# UNITED STATES PATENT AND TRADEMARK OFFICE

APPLICATION NO.	FILING DATE	FIRST NAMED INVENTOR	ATTORNEY DOCKET NO.	CONFIRMATION NO.
10/702,198	11/04/2003	Victor Lee Walker	08168-053001	7120
20985	7590	08/01/2006	EXAMINER	
FISH & RICHARDSON, PC P.O. BOX 1022 MINNEAPOLIS, MN 55440-1022			MITCHELL, KATHERINE W	
			ART UNIT	PAPER NUMBER
			3677

**Office Action Summary**

**DETAILED ACTION**

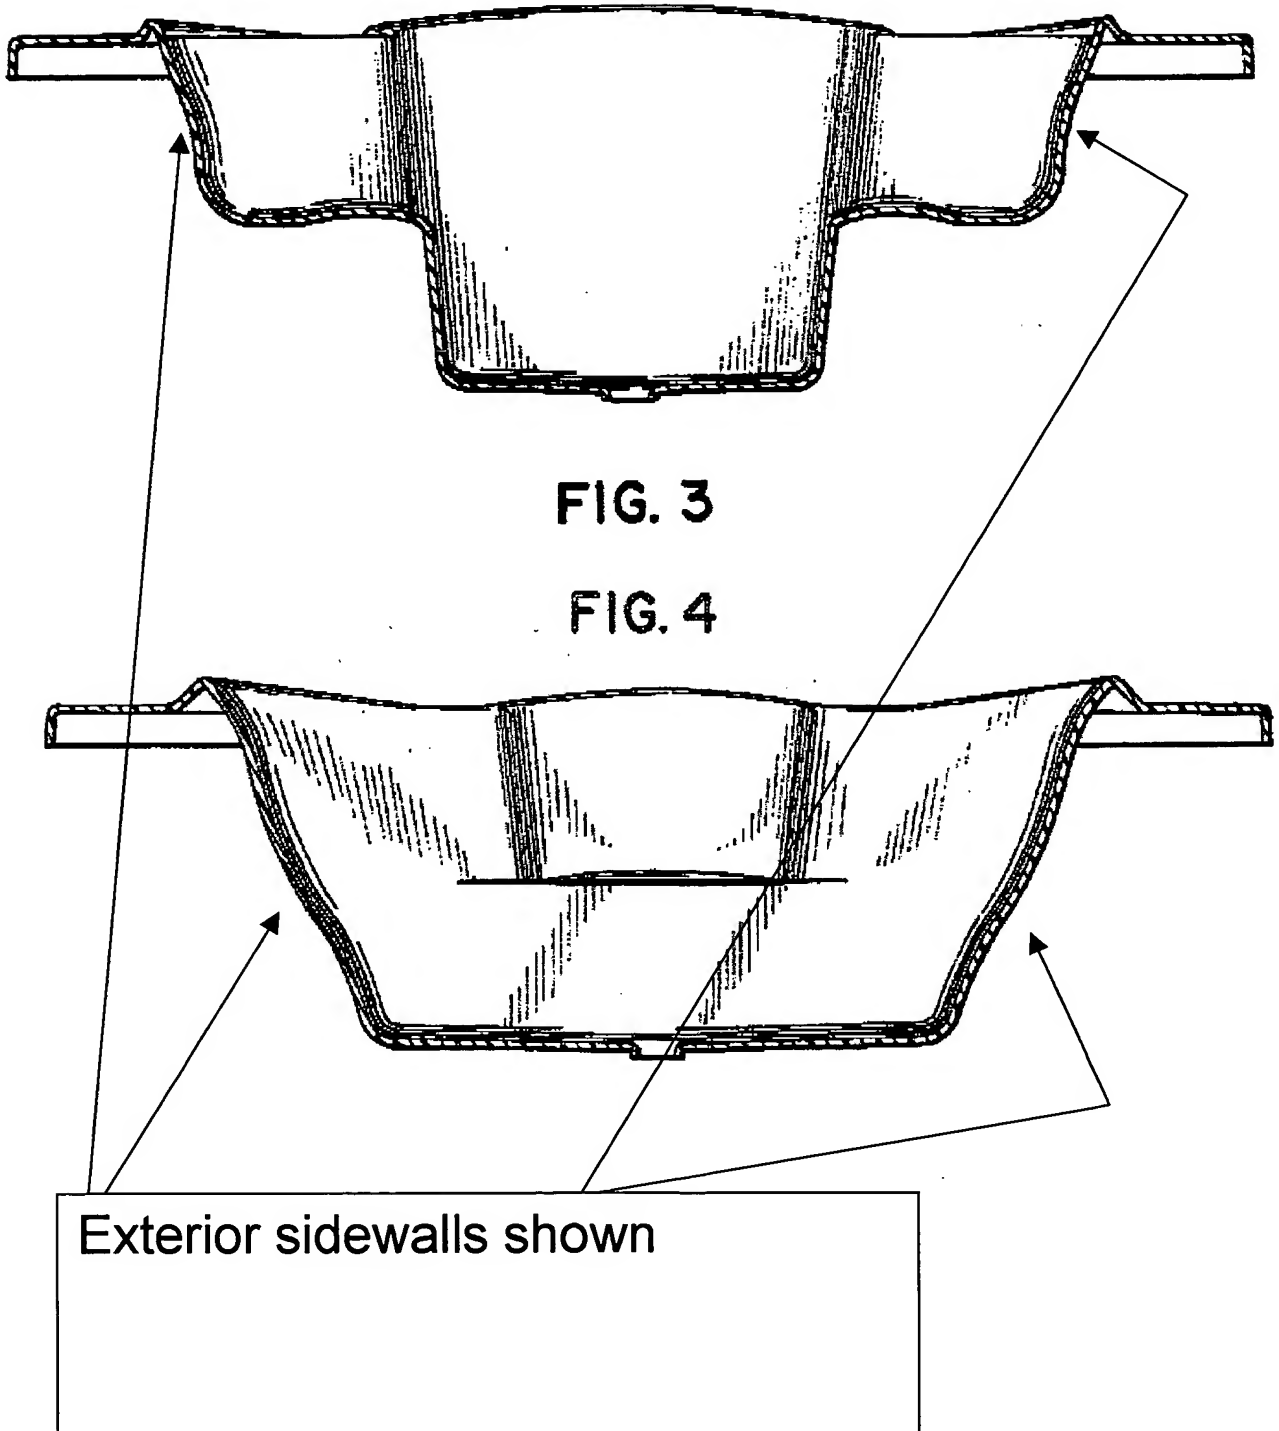
3. Claims 13-14 are rejected under 35 U.S.C. 102(b) as being anticipated by Kohler, Jr., Des.280342, hereafter called Kohler.

Re claim 13: Kohler teaches a curvilinear spa shell comprising:

- a top edge defining a shape of the spa shell, the edge having 4 rounded concave relative to the interior corners (see marked up Fig 2 below—4 corners are marked off by examiner in dashed lines) each corner having a radius that exceeds 12 inches (inherent, as the smaller opposed corners clearly are formed as seats, and a drain is also shown to give proportions clearly in excess of 12" radius for each curved corner) and
- four curved exterior side walls that are convex relative to the interior, each wall connected between two of the concave corners (between areas marked off as

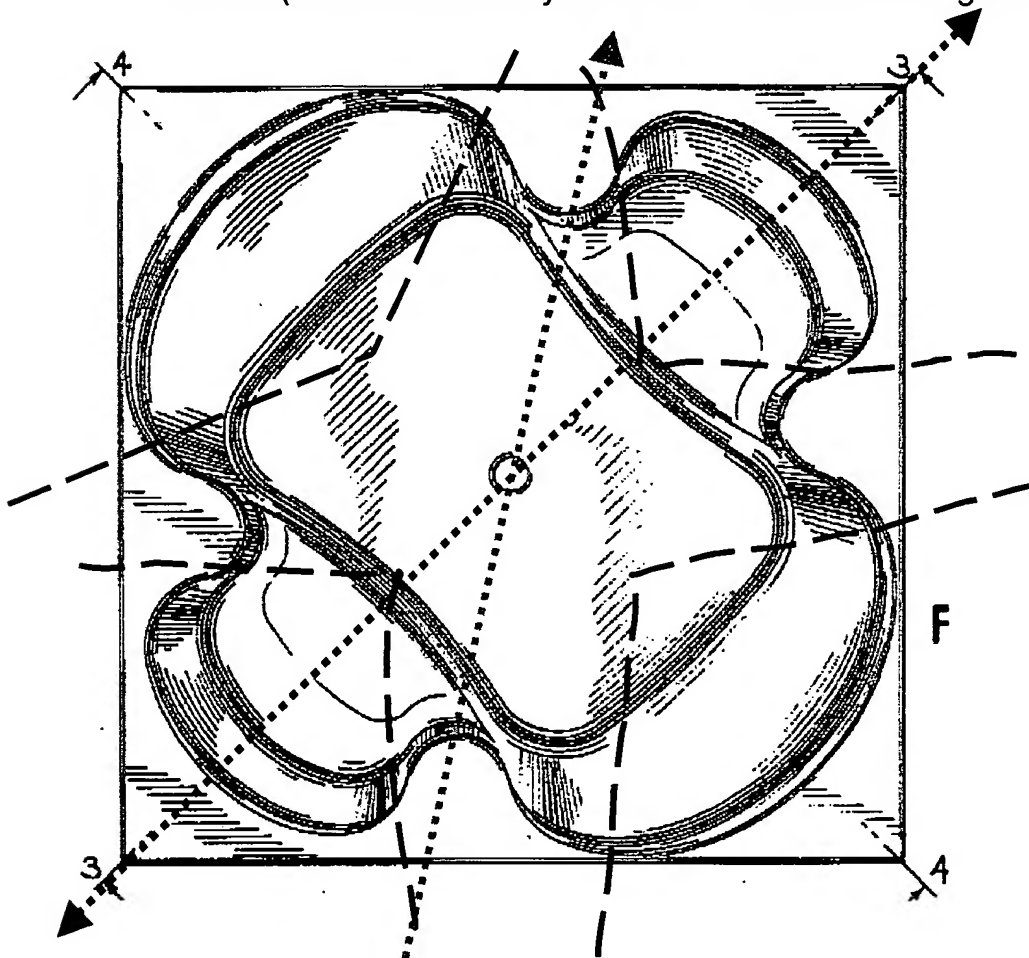
dashed lines by examiner). Note that the walls are clearly shown as exterior sidewalls in Fig. 3 and 4:

- Wherein the top edge is substantially symmetrical both about an axis that bisect the interior through two side walls (orange dotted axis by examiner- -inherent in the figure shown) and
- substantially symmetrical about an axis that bisects the interior through two corners (blue dotted axis by examiner --inherent in the figure shown).

7. Applicant argues that Kohler does not teach 4 curved exterior side walls, but as Figs 3 and 4 clearly show, the walls are indeed exterior sidewalls. The fact that there is a square outer rim does not negate the fact that the sidewalls are indeed curved exterior sidewalls. A lip or rim may exist, but there are still outer sidewalls below the lip.
